Release Notification and Corrective Action

Name of Company	Mesquite SWD, Inc. 1101968	Contact	Riley Neatherlin
Address	PO Box 1479, Carlsbad, NM 88220	Telephone No.	575-706-7288
Facility Name	Big Eddy SWD #1	Facility Type	Salt Water Disposal
Surface Owner	BLM	Mineral Owner	BLM
		API No.	30-015-05819

2RP-4321

Mesquite SWD - Big Eddy SWD #1 disposal
Site inspection September 5, 2017

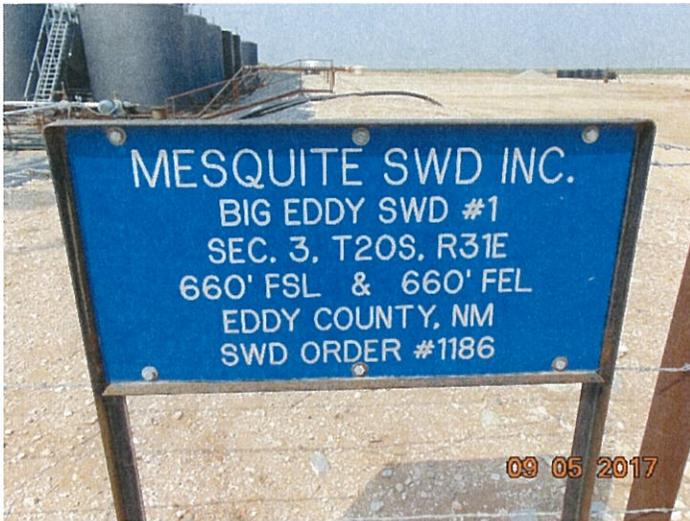
The well ID sign is present, but the R/W ID number **IS NOT** posted.

There appears to have been a failure in one of the two pumps at the site. Produced water (PW) flowed westward from the pump shed toward the well, including the pad surface surrounding what appear to be new concrete footers. The PW also flowed westward, around the south end of the electrical shed, and exited the east side of the facility (which is not bermed).

The surface stain appears to be more petroleum stain than salt deposition. But then, it has been almost a month since the spill, with significant rain; so much of the salt deposited may have washed down into the pad or off the east side of the pad.

The contamination appears to have run about 50-feet outside the east fence, and pooled in an area about 30-feet in diameter. There is petroleum staining and a little salt bloom; and shrubs around the north side are dead.

Also observed at the NW corner of the deep excavated containment for the main tanks was a pile of contaminated material, about 1 cy, that might have been scraped out of the containment. It should be removed when the contamination from the spill is removed.

Also noted: two chemical tanks along the top of the deep containment have secondary containment tubs below them. But the secondary containments are barely bigger than the tanks - if a hole were punctured in the chemical tank, the chemical would spurt out far beyond the containment. This situation must be remedied. Also, netting of the containments against wildlife entry was not properly installed.

The R/W ID information must be posted on site as required by the R/W Grant documents.

Mesquite must coordinate with both OCD and BLM on the approvals of all delineation plans, remediation plans, and approval of confirmation samples prior to backfilling.
